REGIONAL REVIEW NOTIFICATION

ARC REVIEW CODE: R502242

Name of Proposal: Corporate Campus

Review Type: Development of Regional Impact

PRELIMINARY
SITE PLAN

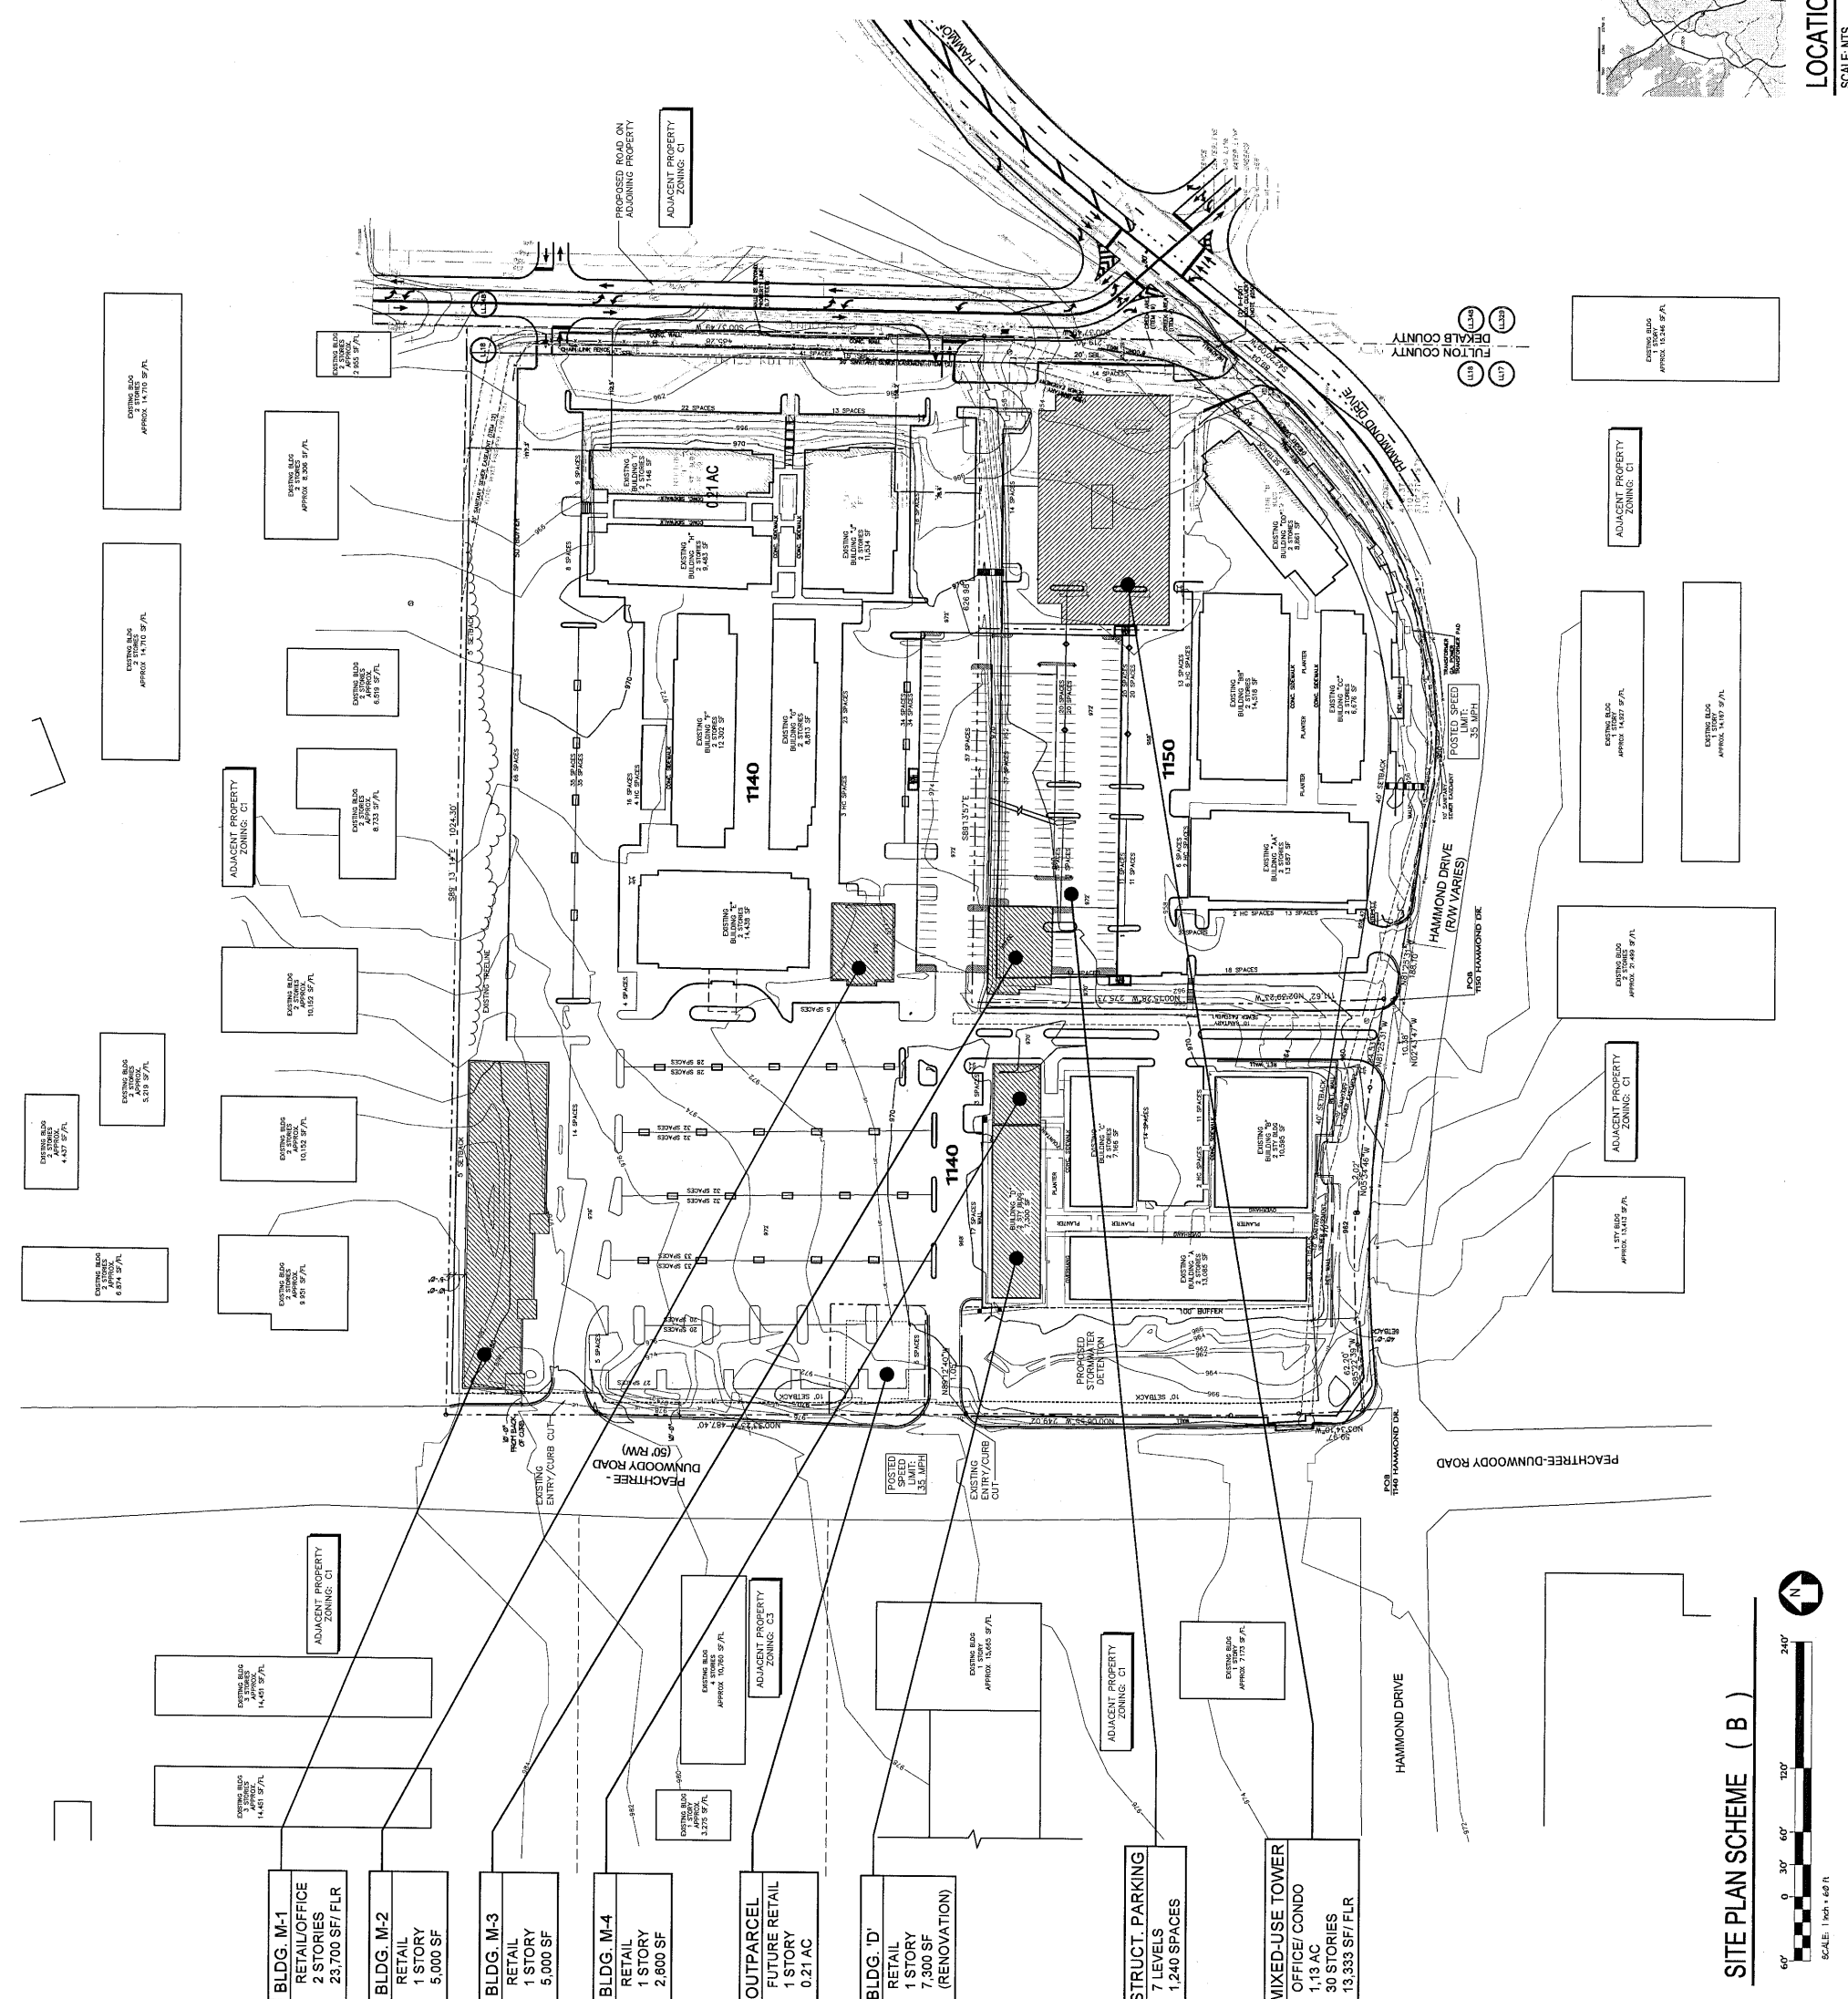
The development presents the opportunity to create a grid street network within the block. The site plan begins to suggest this with the proposal of two continuous connections through the site from existing driveways A and B to the proposed new road on the eastern border of the property. It is recommended that the site plan reflect the grid street network by pulling the driveway from existing driveway C through the site to connect with the proposed cross driveway on the northern portion of the property at existing driveway A. Proposed buildings along the internal “main” driveways or streets should interact with the street. Sidewalks and pedestrian amenities should be included along these internal streets to create a true pedestrian friendly main street. Building M-1 should have continuous street frontage on both the north and south sides of the building. Building D should have continuous street frontage on both the north and south sides of the building as well. Any future redevelopment should interact with the established grid of the internal streets.

It is recommended that the stormwater detention pond proposed at the corner of Peachtree-Dunwoody Road and Hammond Drive should be screened from view of the road. Vegetation should be planted along the sidewalks and existing retaining wall to create a safe and attractive space for pedestrians along the sidewalk.
